Re: 59 Orchard Beach Boulevard Foundation and Structural Assessment
Response to comments from FEMA building Science
Port Washington, New York
MRCE File 13891

Mueser Rutledge Consulting Engineers PLLC (MRCE) has been retained by Pond Ridge Homes LLC to perform a Geotechnical and Structural Engineering Peer Review of Demerara Engineering's (DE) structural and foundation design for 59 Orchard Beach Boulevard (Block 59, Lot 636) in Port Washington, New York.

Figure 1 - Wall Removal

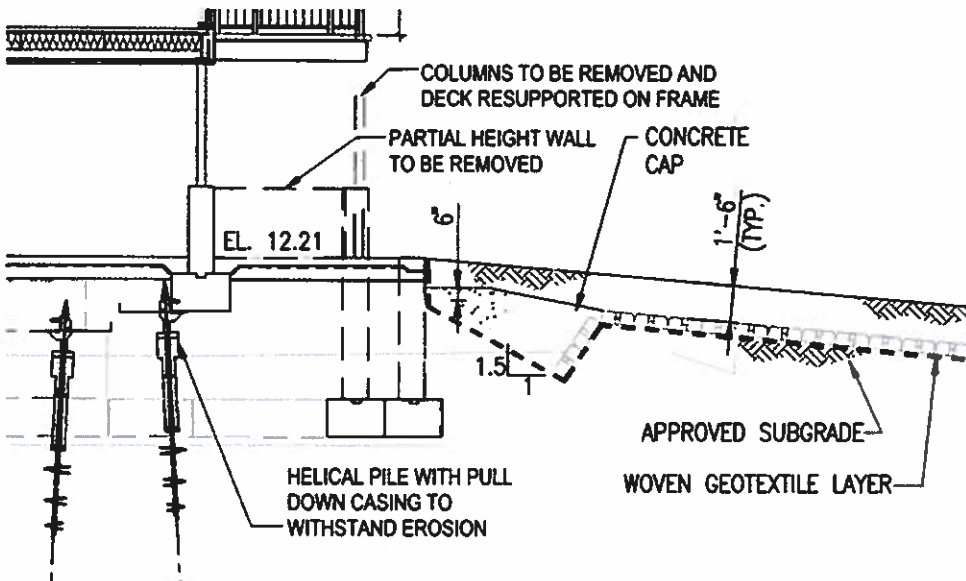
FEMA Comment: FEMA states that “the shore parallel, retaining wall appears to provide grade control for the seaward extent of the parking area and must be evaluated for free of obstruction requirements outlined in NFIP TB-5. If the retaining wall is providing foundation support for any component of the structure, the wall would be considered an obstruction in the V zone as it is oriented parallel to the shoreline. Additionally, the plans indicate that steel columns for the deck bear on the retaining wall. Section 6.2 of NFIP TB-5 provides additional guidance for decks and their foundation requirements when located in V Zones. Please note that the addition of flood openings to these walls would not render the walls compliant with VE requirements.”

MRCE Response: The rear partial height wall, approximately 3 feet in height, is not a retaining wall and does not provide grade control. In response to FEMA comments, the partial height wall will be removed entirely as shown in Figure 1. A discontinuous 6” curb will be installed along the southern edge of the building to prevent vehicle roll off. The modified design Drawings prepared by Demerara in Appendix C show the extent of wall removal.

Figure 3- Foundation Offset

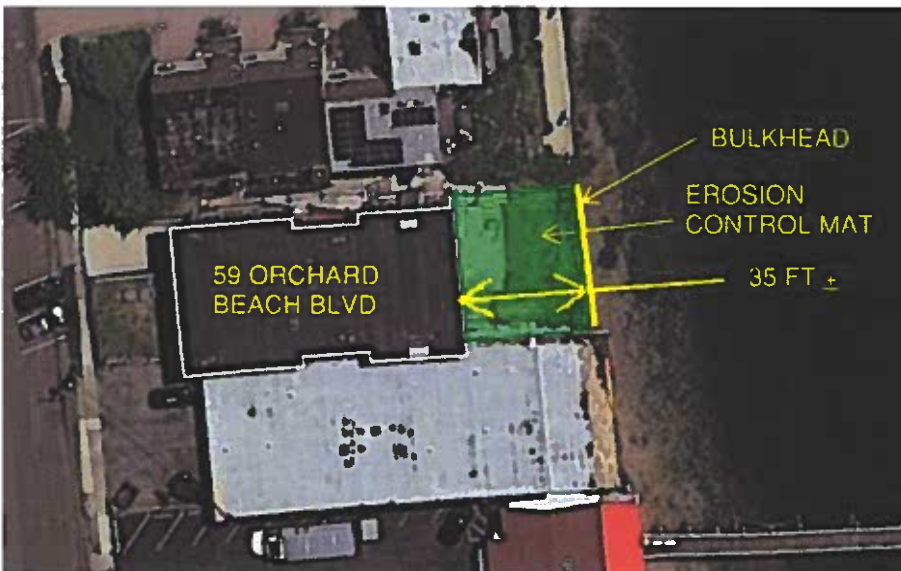
FEMA Comment: FEMA states that “For the retrofit of the existing shallow foundation system with helical piles to be successful, the helical piles must not be subject to erosion and scour effects. The designer should evaluate the existing bulkhead and other associated erosion control measures should be evaluated for their ability to survive and maintain site grade when subject to the loading associated with base flood conditions. Since the helical piles are protected by these erosion control measures then the designer should evaluate what the consequences are if any of these measures fail.”

MRCE Response: We confirm that these evaluations have been made which demonstrate the adequacy of the bulkhead and proposed erosion control measures to protect the piles under the design flood event. The helical piles are designed with an outer steel casing to increase lateral pile capacity and withstand local scour or erosion around the pile to a depth of up to 5 feet (depth below slab). The helical piles will therefore remain effective in supporting the elevated structure following scour beneath the parking slab. However, for added protection, the building design adopts a “belt and suspenders” approach of designing piles to withstand erosion and also adding an erosion control mat overlain by a vegetated landscape that will greatly alleviate the risk of erosion given the horizontal offset of more than 30 feet between the building foundations and the bulkhead. NFIP Technical Bulletin 5, Section 7.3 recommends a desirable splash zone width of 30 feet between the bulkhead and the building or a reasonable minimum splash zone width of 10 feet to 15 feet. As shown in Figure 3, the closest pile foundations are set back approximately 35 feet from the bulkhead which exceeds FEMA’s coastal mapping guidance for building position landward of the bulkhead erosion control structure.
